Bayside Planning Panel

Item No	6.2
Application Type	Development Application
Application Number	DA-2016/66/A
Lodgement Date	09/03/2017
Property	4 Magdalene Terrace Wolli Creek
Owner	Maroun Pty Ltd
Applicant	Design Workshop Australia
Proposal	Modifications - Addition of 1 storey to previously approved development, including 9 additional residential units to create a total of 109 units and reconfiguration of basement 2 level to include additional parking spaces
No. of Submissions	Nine (9)
Cost of Development	\$9,083,496.00
Report by	Fiona Prodromou, Senior Assessment Planner

Planning Assessment Report

Application Number:	DA-2016/66/A
Date of Receipt:	9 March 2017
Property:	4 Magdalene Terrace, WOLLI CREEK (Lot 2 DP 1064374)
Owner:	Maroun Pty Ltd
Applicant:	Design Workshop Australia
Proposal:	Modifications - Addition of 1 storey to previously approved development, including 9 additional residential units, to create a total of 109 units and reconfiguration of basement 2 level to include additional parking spaces
Recommendation:	Refused
No. of submissions:	Nine (9)
Author:	Fiona Prodromou
Date of Report:	28 March 2018

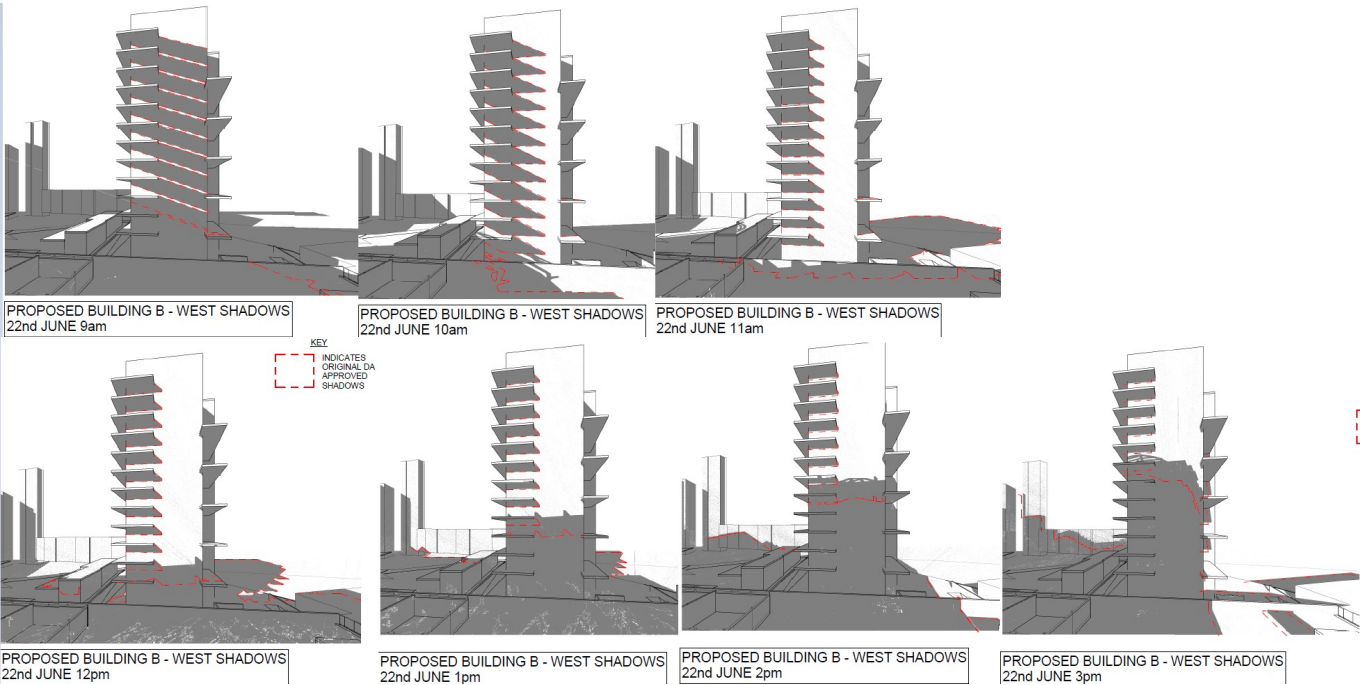
Elevational shadow diagrams illustrating the approved and proposed shadows onto the western and northern facades of Building B were submitted with the application. These diagrams illustrate the additional overshadowing that arise to the northern and western facades of Building B, with the central podium communal courtyard of the Proximity development as a result of the proposed additional level.

Further to the above, it is noted that submitted elevational shadow diagrams depicting the northern and western façades of building B do not accurately illustrate window openings and balcony locations, as can be seen below.

Notwithstanding the above, elevational shadows to the western façade of Building B illustrate as follows, with the red outline depicting the original approved shadows.

The above shadows demonstrate that a minimum of 2 hours of solar access is achieved in midwinter between 10am - 12pm to the west facing window / balcony openings to units within Building B of Proximity. This complies with the requirements of the Apartment Design Guide (ADG). The proposal as modified will however result in further overshadowing of an additional lower level of Proximity Building

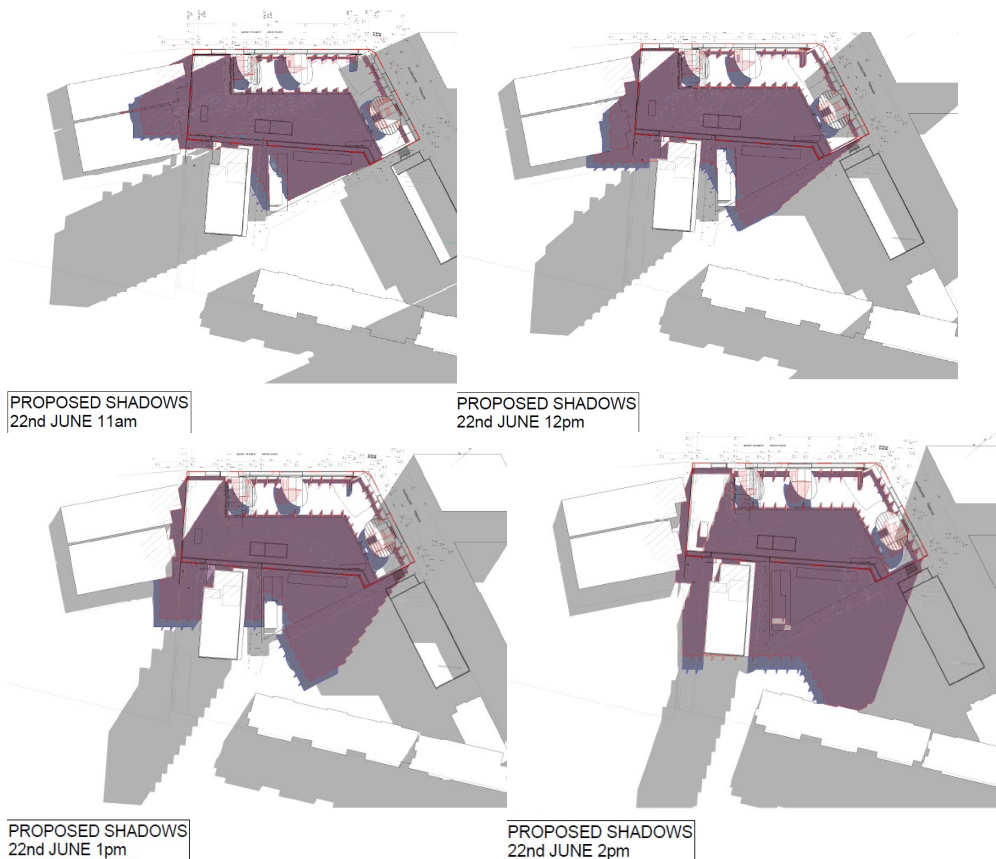
Prior to the approval of the original DA, half of the Proximity pool was in sunlight at 10am in midwinter.

The approved development, overshadowed the pool entirely at 10am. At 11am - 12pm in midwinter this pool is overshadowed completely by the shadow generated by Buildings 3 and 5 at 1-7 Magdalene Terrace. The shadow onto the pool as caused by the approved development was no greater than this shadow and the pool remained in shade at this time. At 1pm - 3pm in midwinter, the pool is overshadowed by the previously approved development.

Given the above, it is evident that as a result of the location of the proximity pool, the approved development and existing shadows caused by neighbouring buildings to the north, the pool at podium level will receive nil sun in midwinter.

The proposal as modified does not result in further overshadowing to the pool area, given the aforementioned.

Building element protrusions to Magdalene Terrace

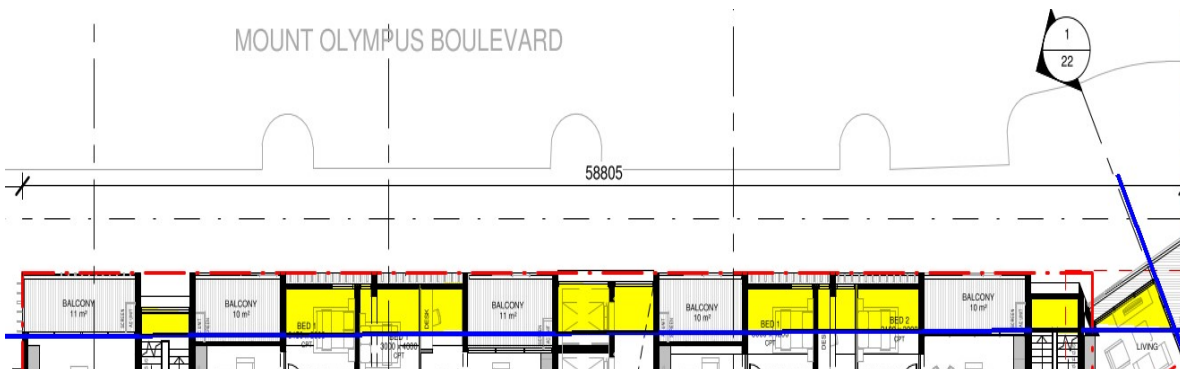
Accordingly, a 2m building setback is required to both frontages of the site, of which a further 2.5m articulation zone is also required. The articulation zone is intended to comprise only balcony elements.

The development as approved complies with the 2m building setback to both frontages, with building elements protruding into the articulation zones at both site frontages as can be seen in yellow below.

As approved, the design of the development alternates on each level, with balconies proposed within the articulation zone on Levels 2, 4, 6 and 8 and a mix of floor space and balconies on Levels 3, 5, 7 and 9. The proposal as modified remains consistent with the aforementioned and illustrates partial protrusions within the articulation zone.

Figure 7 - Example of revised snorkel bedroom

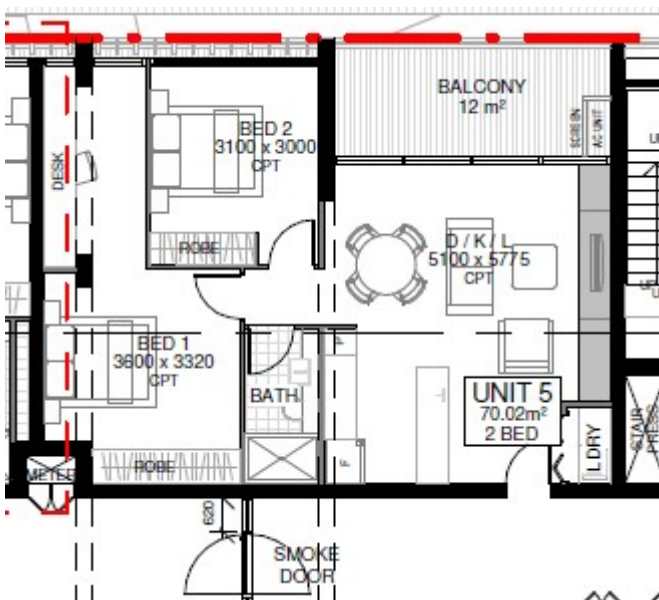
The DRP notes that *'Snorkel bedrooms in units 3 and 5 have poor amenity and are to be reconfigured and that overlooking from the elevated pool to adjacent bedroom windows should be reviewed.'*

Comment: Plans have been revised to delete the majority of snorkel bedrooms. Where these have been retained, the area of the 'snorkel' has been widened and incorporates floor to ceiling glazing and a study nook in order to maximize the use of this space and provide for appropriate solar access and outlook to the subject bedroom as can be seen below.

Figure 8 - Schedule colours and finishes

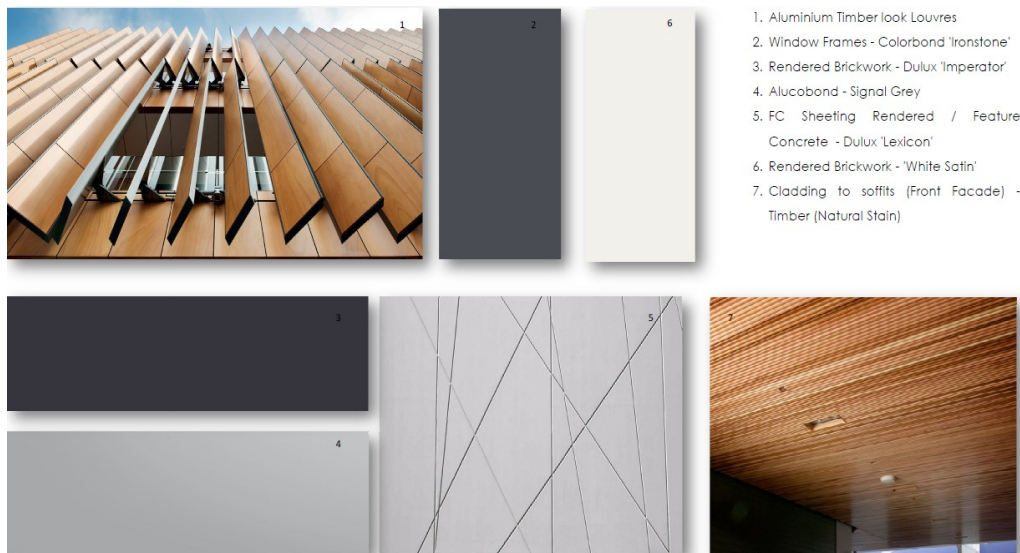
The DRP further noted that *'the materials proposed for the podium should be reviewed to better integrate with the residential component of the building.'*

Comment: Materials and colours at podium level are provided as per the submitted schedule of colours and finishes below, these are satisfactory and will ensure the entire development presents as a unified building form. To ensure the finishes and materials of the podium facade to the future park are appropriate, the proposal has been conditioned to require the submission and approval by Council of the final design details of the proposed external materials and finishes, including schedules and a sample board of materials and colours prior to the issue of the Construction Certificate. Details of the treatment of the exposed side wall (future open space) at No. 16 Guess Avenue and the wall parallel to the podium of the adjacent building are required to be included.

Figure 9 - Building separation with Building E of Proximity Development

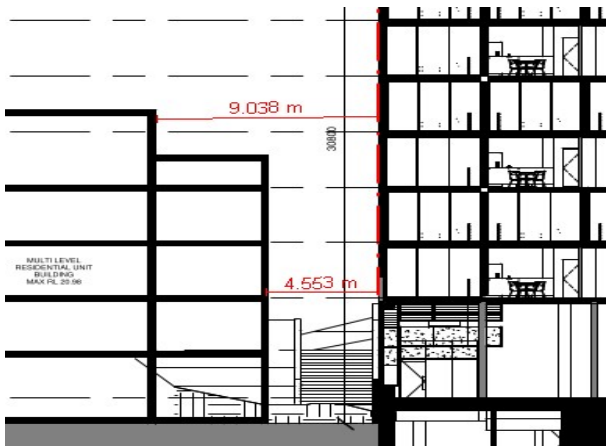
As noted in the table above, the proposed development departs from the design criteria of the ADG which recommends a 6m minimum separation between the proposed development and Building E of

the Proximity development fronting Magdalene Terrace. A 1.44m deficiency in building separation exists as proposed. The objective of this part of the ADG is to achieve reasonable levels of external and internal visual privacy between neighbours.

Figure 11 - Proposed height variation above blue line

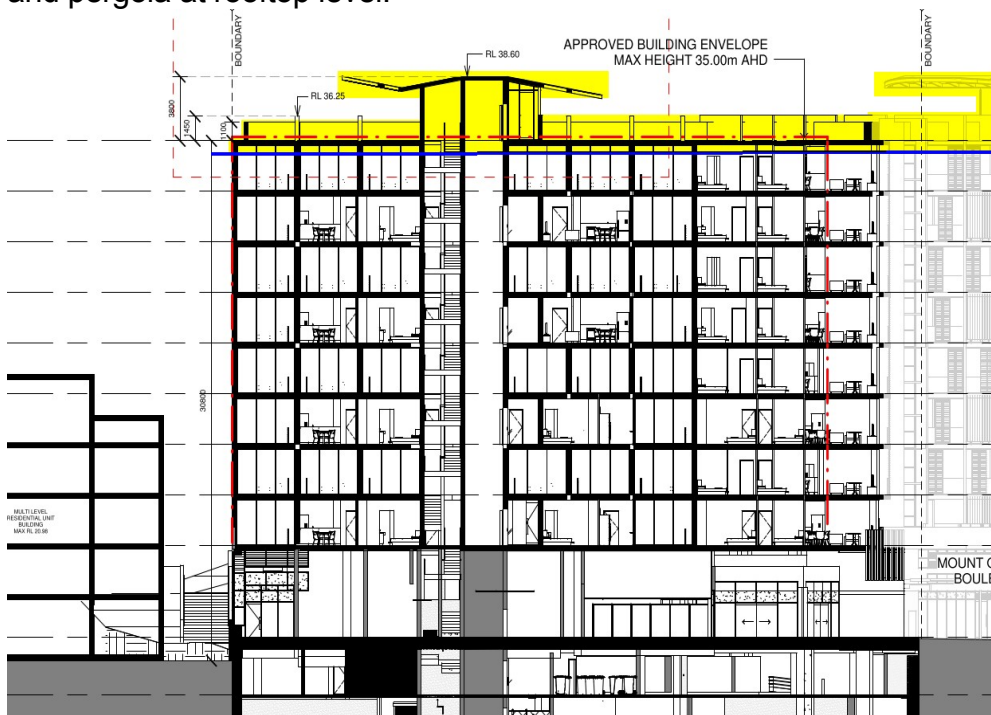
- 31.8m roof of building (34.8RL)
- 32.92m top of balustrade (35.92RL)
- 33.25m top of vertical feature element to building facades (36.25RL)
- 35.6m top of the lift/stair overrun and pergola (38.6RL)

As can be seen above, the proposed development seeks to vary the maximum height limit on site by 0.8m - 4.6m. This is a proposed variation of 2.5% to the roof of the building, 6.1% to rooftop balustrades, 7.2% to vertical architectural rooftop features and 14.8% to the top of the lift / stair overrun and pergola at rooftop level.

Figure 13 - Shadow diagrams

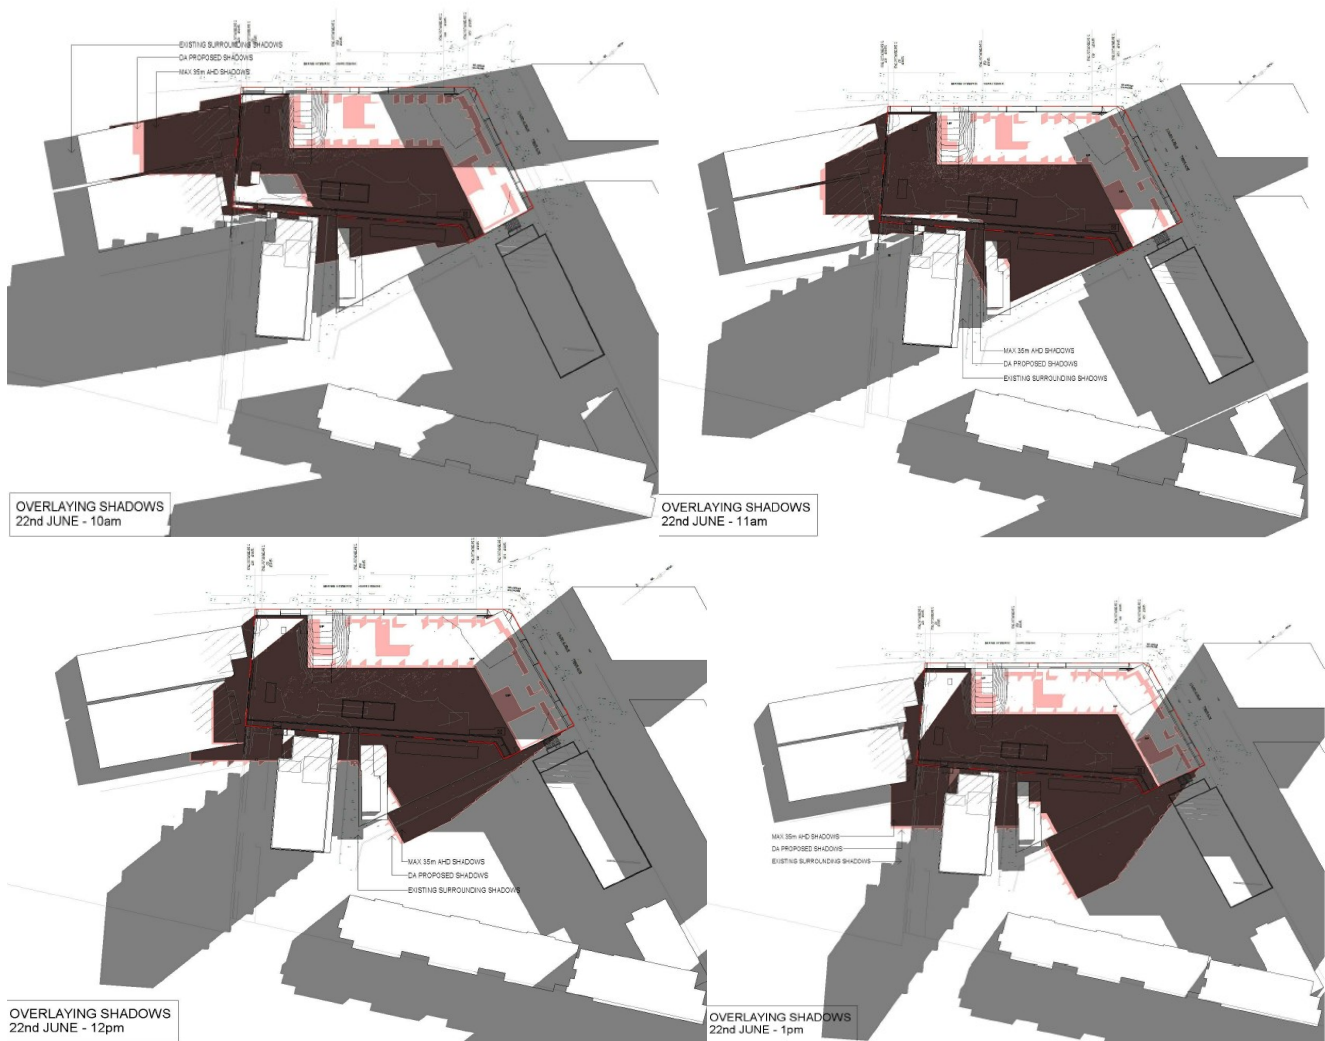
As existing at 9am in midwinter the garden podium communal open space area within Proximity is entirely overshadowed by the existing Proximity buildings and developments on the northern side of Magdalene Terrace. At 10am 1/3 of the gardens are in sunlight, this area will remain in sunlight at 10am with the proposed development. At 11am -12pm as existing approximately half the garden is in sunlight, this area will remain in sunlight at this time with the proposed development generating minor additional overshadowing. At 1pm as existing, approximately 1/3 of the gardens are in sunlight, the proposed development generates minor additional overshadowing, yet 1/3 of the gardens remain in sunlight.

During the times referred to above, it is clear that the Proximity gardens will retain a minimum of 3 hours of sunlight in midwinter between the hours of 10am - 1pm for 1/3 to 1/2 of the overall area of the gardens. This is considered to be acceptable and satisfactory with regard to the objectives of this clause. It is further noted that from 1pm - 2pm some level of sunlight is provided to the south eastern corner of the podium communal open space area within the Proximity development, with this area being entirely overshadowed by the proposed development at 3pm.

Figure 15 - Building element protrusions to Mount Olympus Boulevard

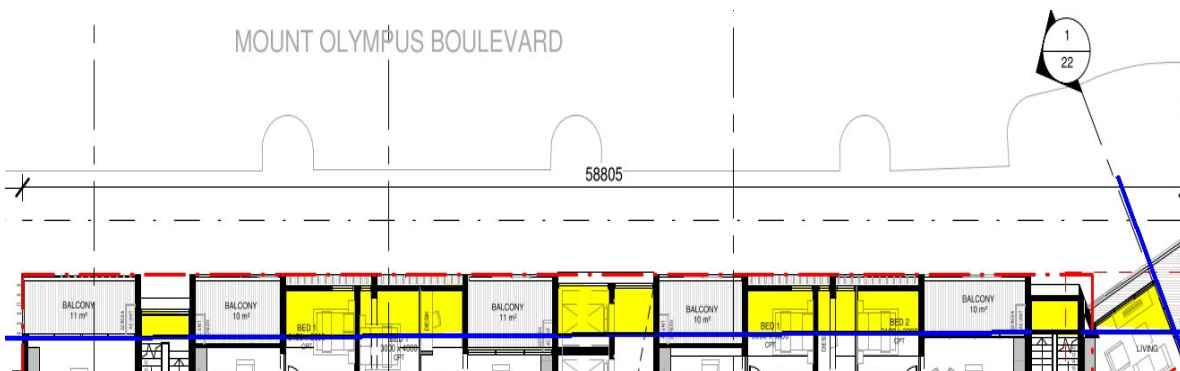
With respect to building protrusions to the Mount Olympus Boulevard frontage of the site, it is noted that the proposed development shall be the only building directly fronting Mount Olympus Boulevard. Given the intended future public park to the rear of the site and future desired context, the minor building protrusions are not considered to be unreasonable.

Figure 16 - Approved interface between podium of 4 Magdalene Terrace and Proximity

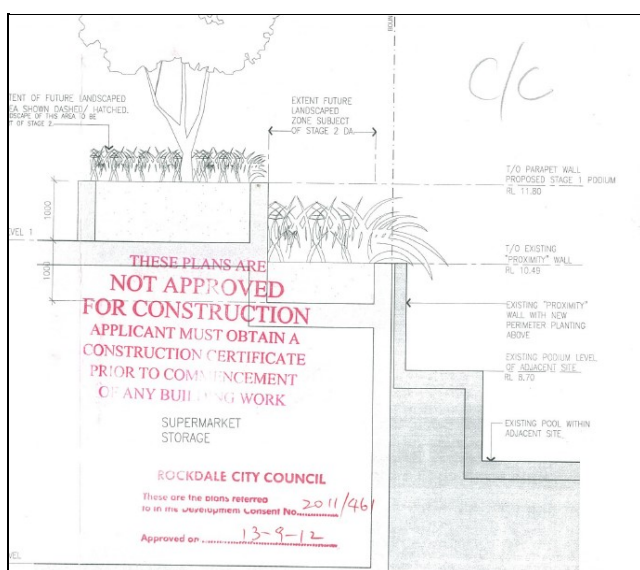
As previously mentioned within this report, the approval (DA-2011/461) set the ground floor and podium levels of the development. DA-2011-461 approved the podium level of the development upon 4 Magdalene Terrace at 10.8RL. This is 2.4m higher than the communal open space level (8.4RL) of the adjoining Proximity development. In order to mitigate the extent of the variation in levels between the two developments, DA-2011/461 was approved with a stepped landscaped planter at 9.8RL stepping up to 10.8RL and spanning the entire length of the common boundary between the sites. This stepped planter is retained as previously approved as part of the current application.
